# RFB-2022-55 SCHENECTADY COUNTY MAIN LIBRARY AHU REPLACEMENT

### **ADDENDUM #2**

### 9/28/2022

DRAWING TITLE **BASEMENT DUCTWORK PLAN**

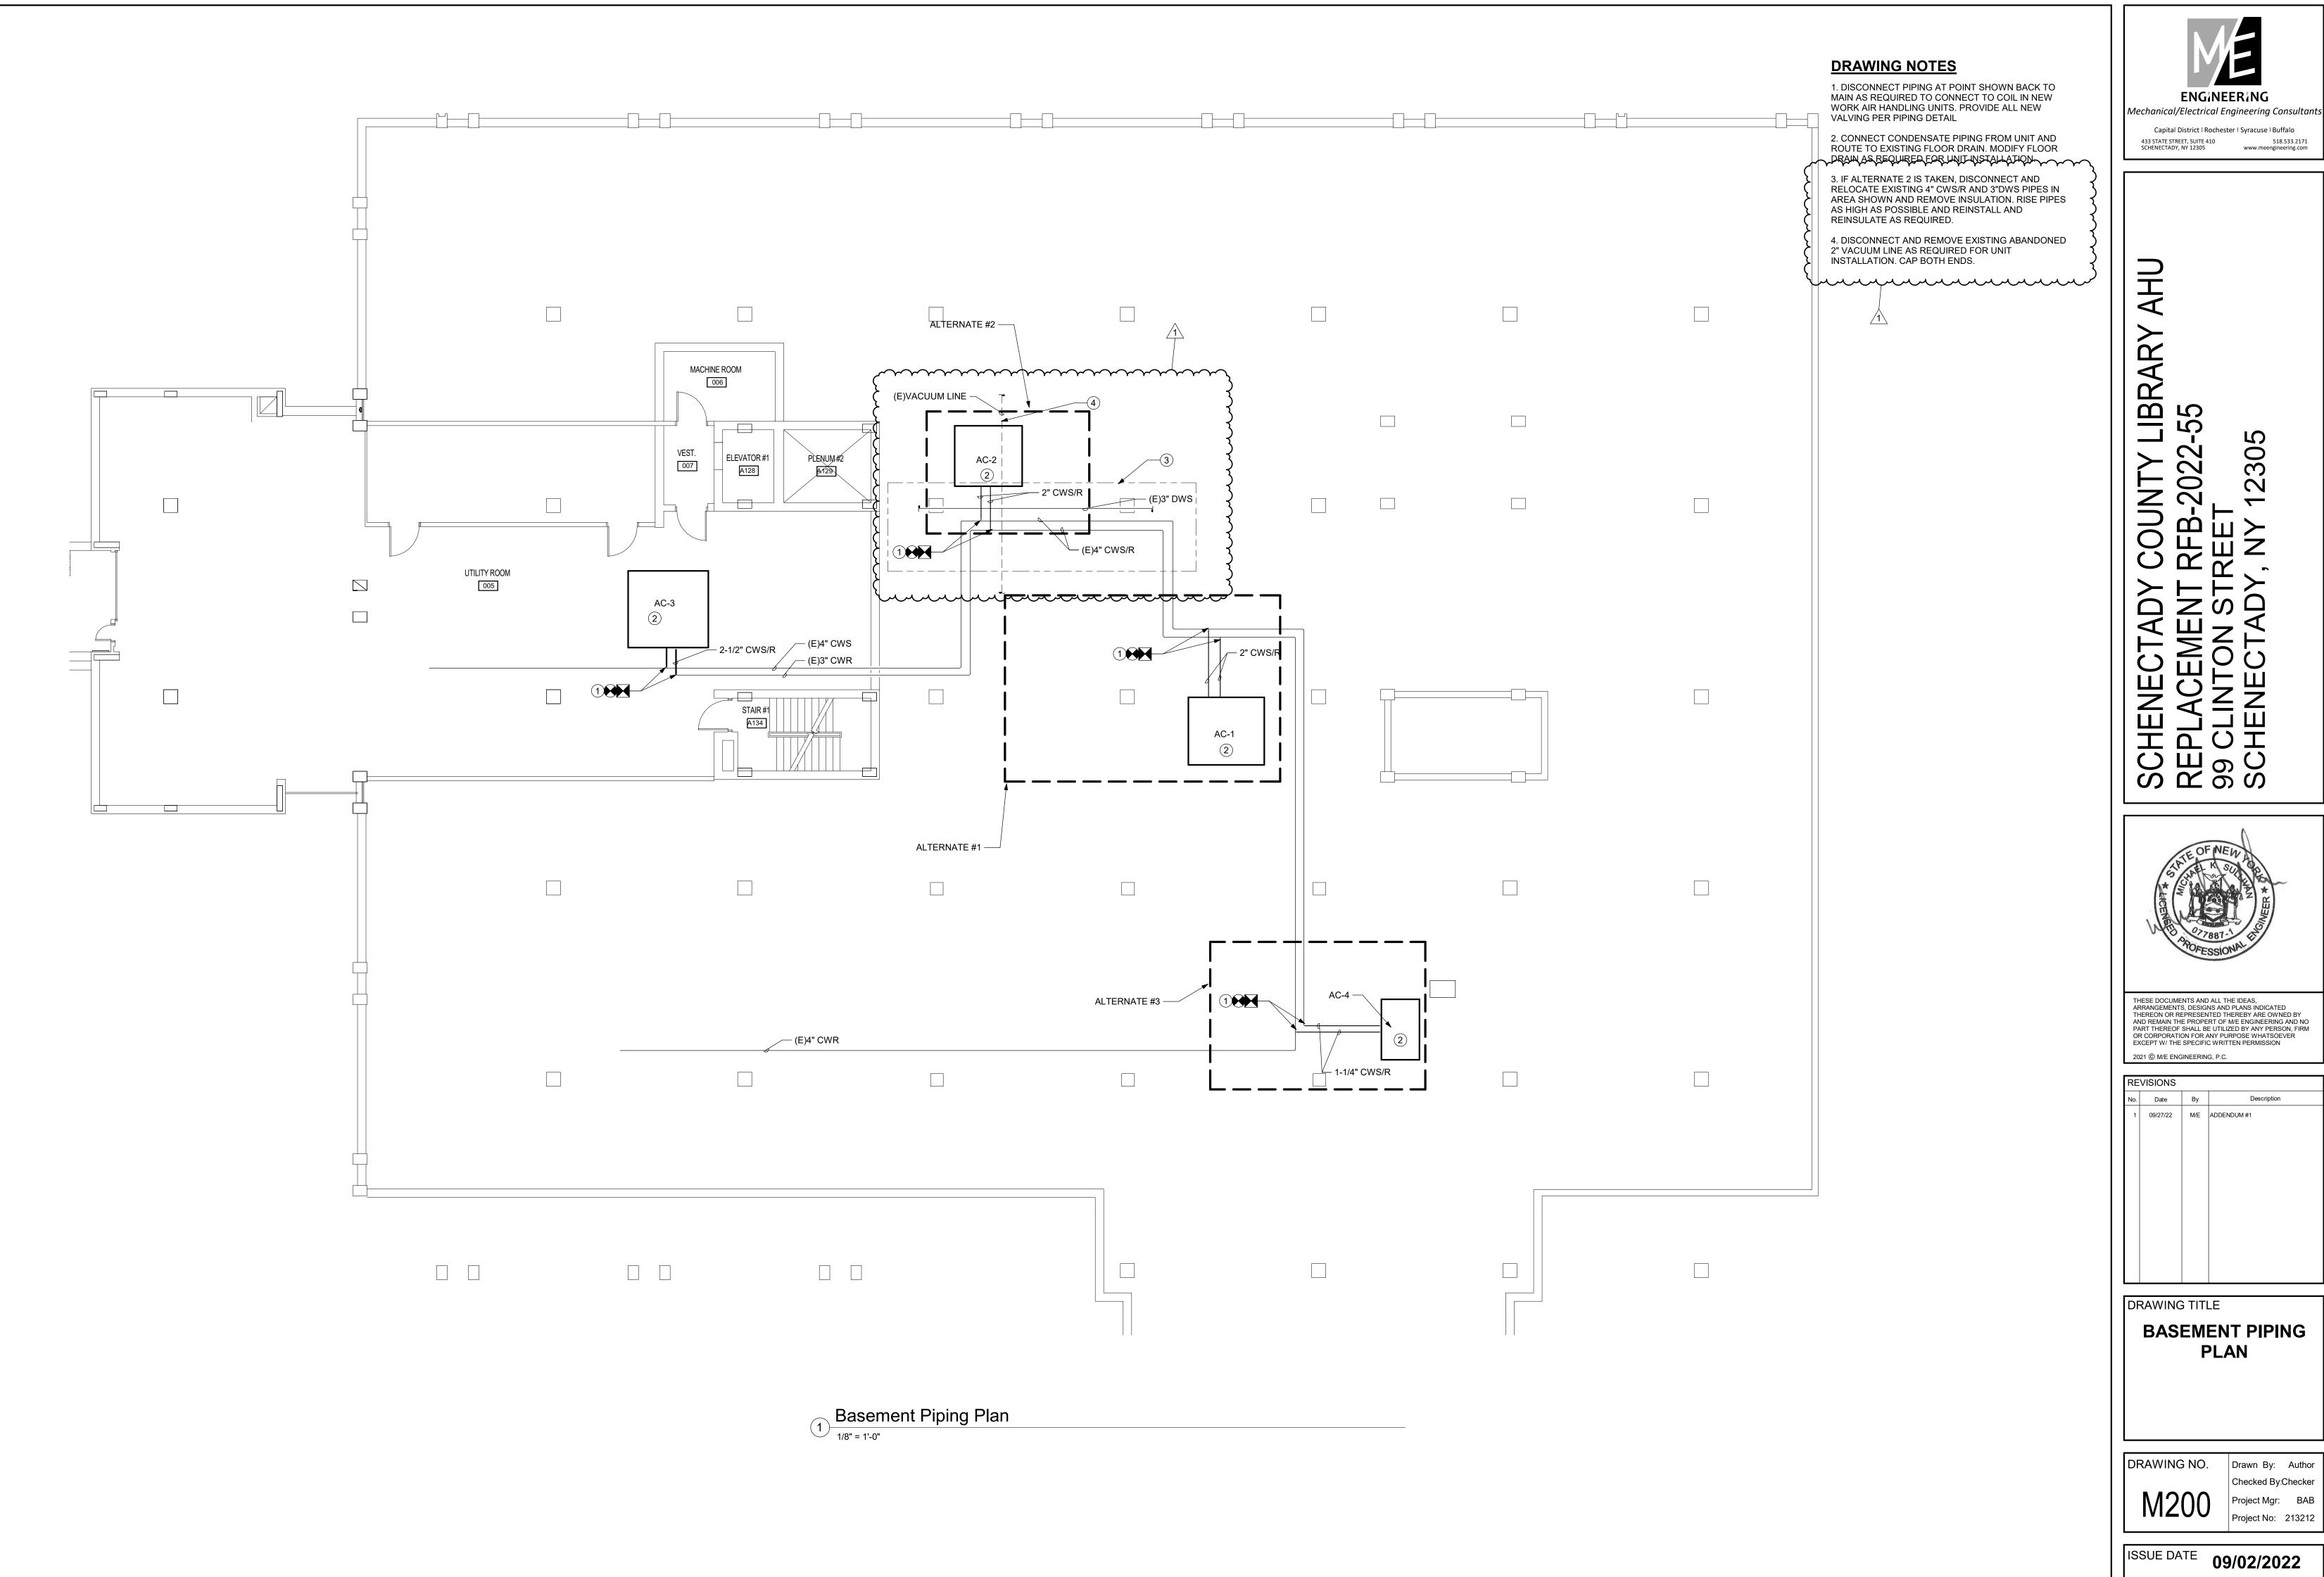
Some of the sections for AC-1 and AC-2 will be too large to fit through the access door or the duct opening called out to be removed/replaced for rigging. Please provide direction or any alternate solutions.

Increase the existing duct opening from 50"x50" to 64"x50". See updated drawings.

**BASEMENT PIPING PLAN**

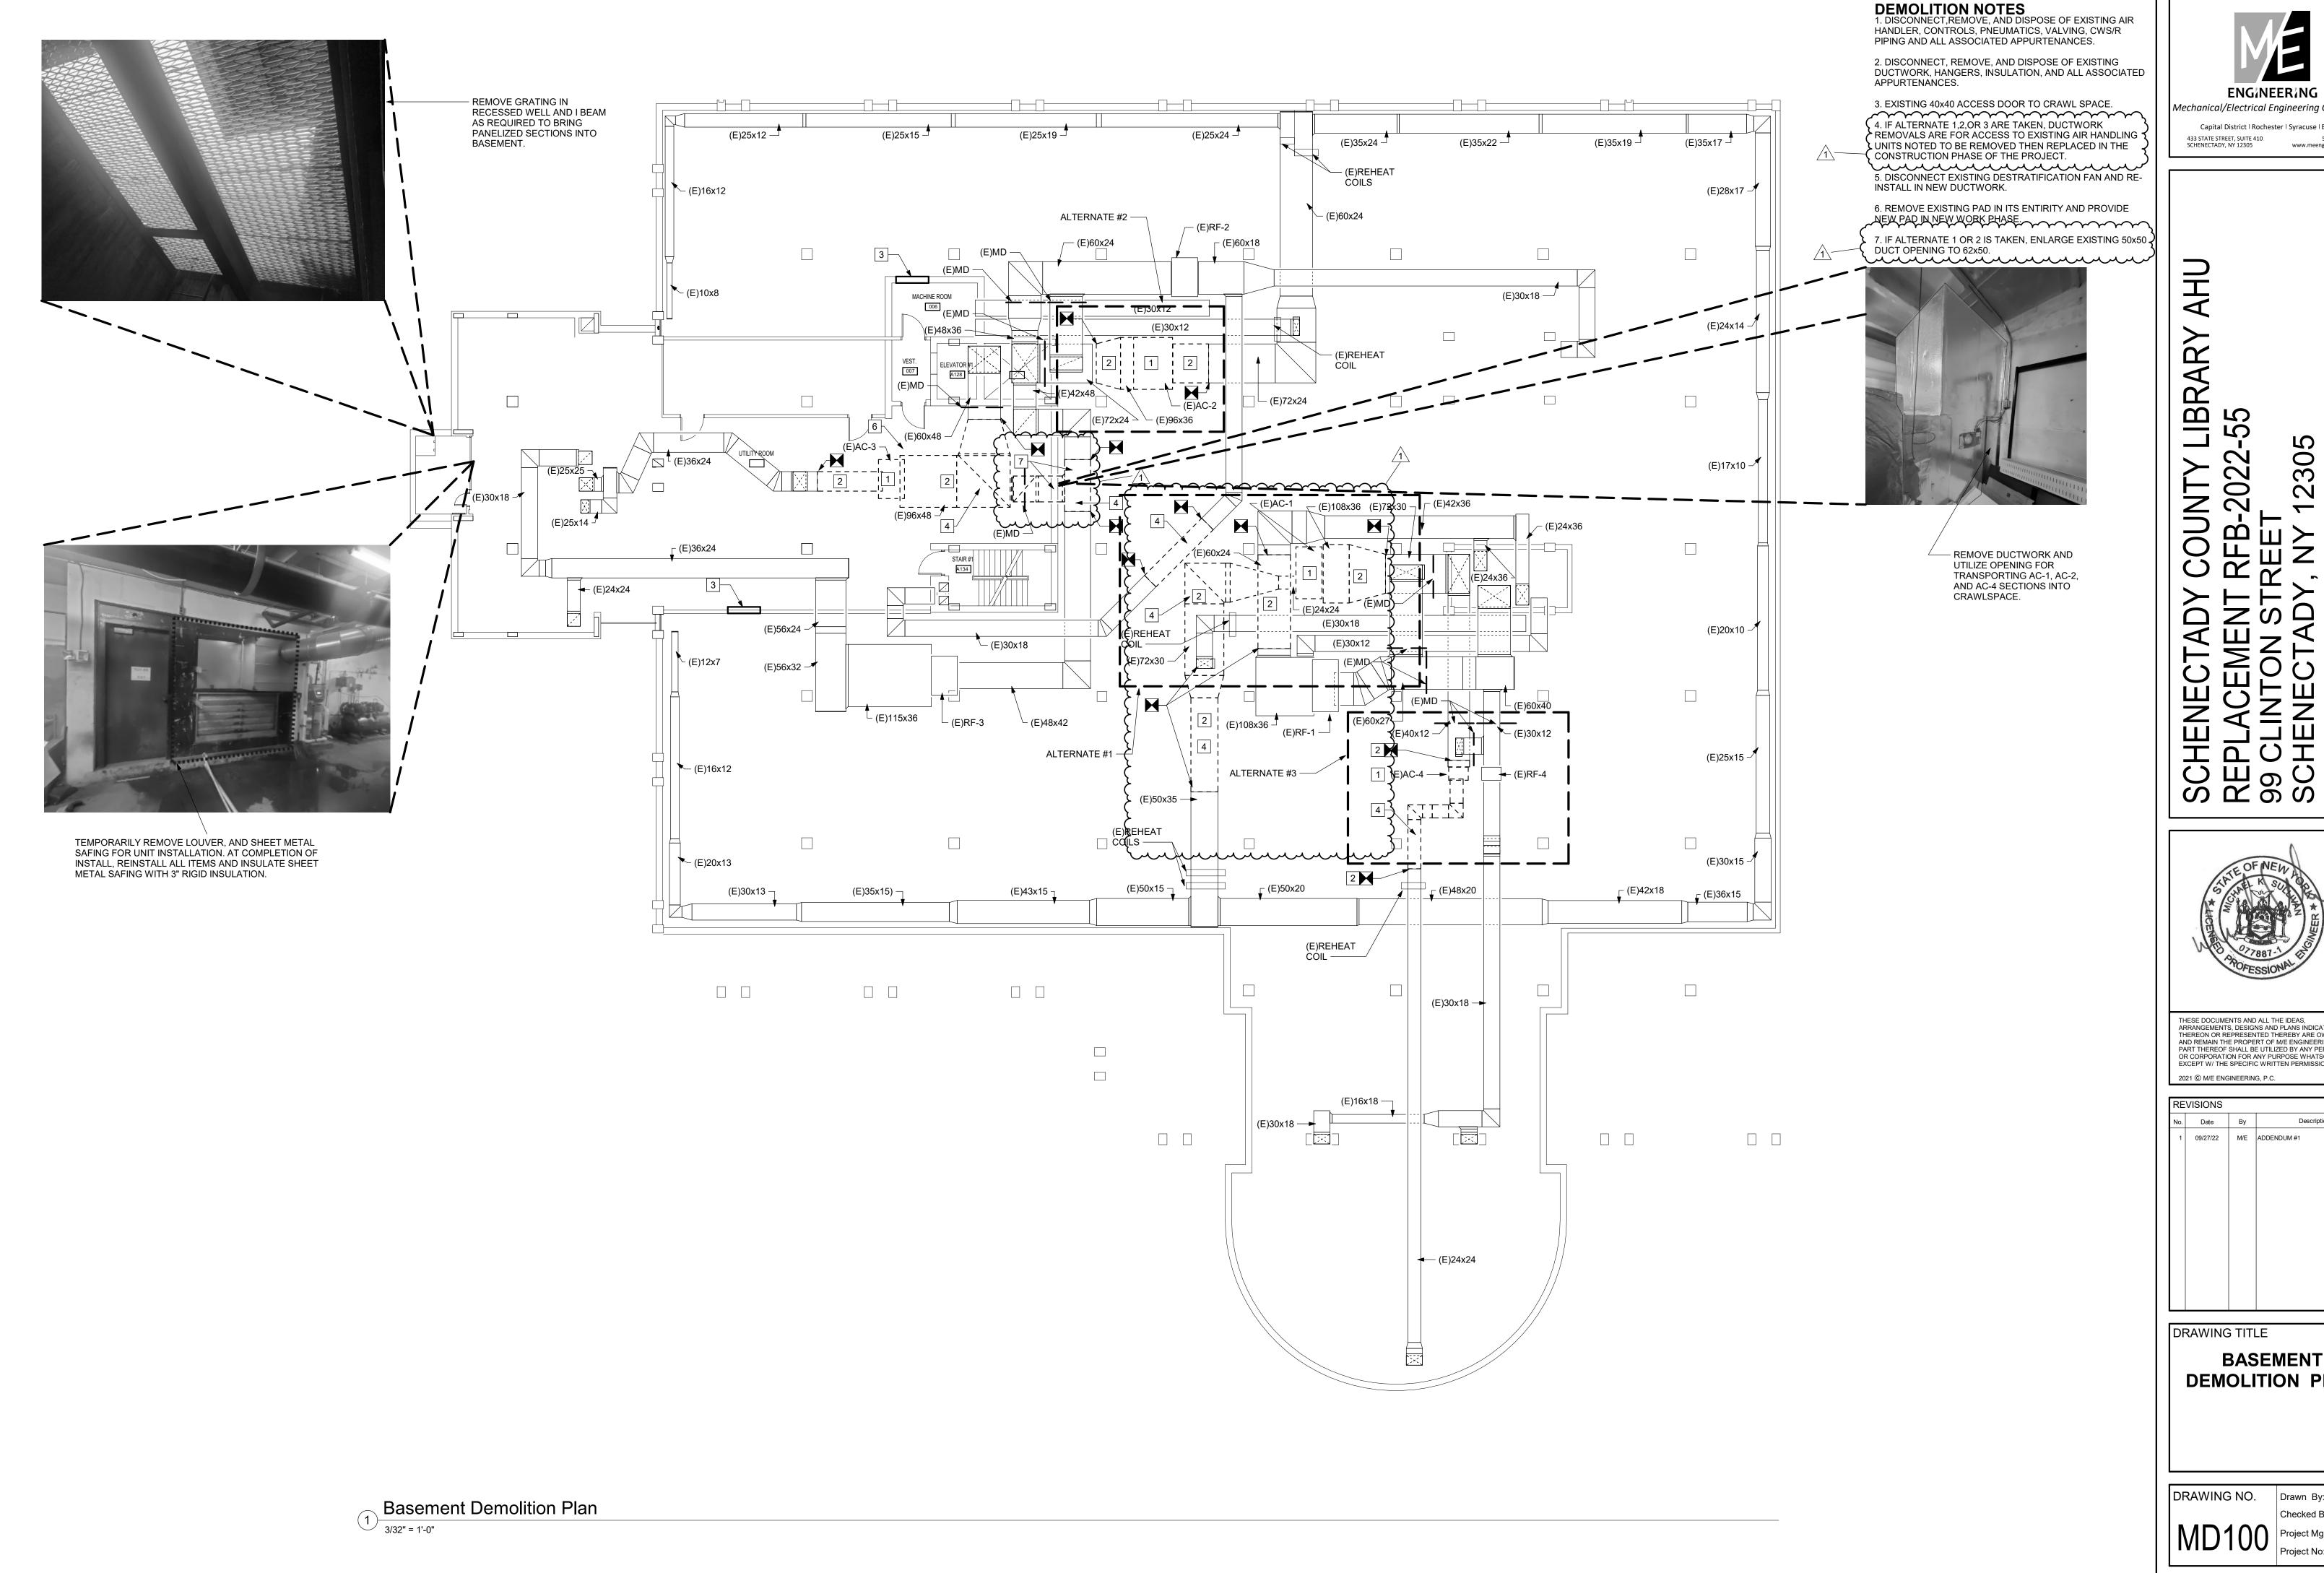
In order to rig the AHU sections to their specified locations some of the existing piping will need to removed/replaced (drain, refill, reinsulate...). Should this work be included? Yes, the existing 4" chilled water supply, chilled water returns and the 3" dual water supply piping near existing AC-2 should be remove, raised, and reinstalled as high as possible. See updated drawings
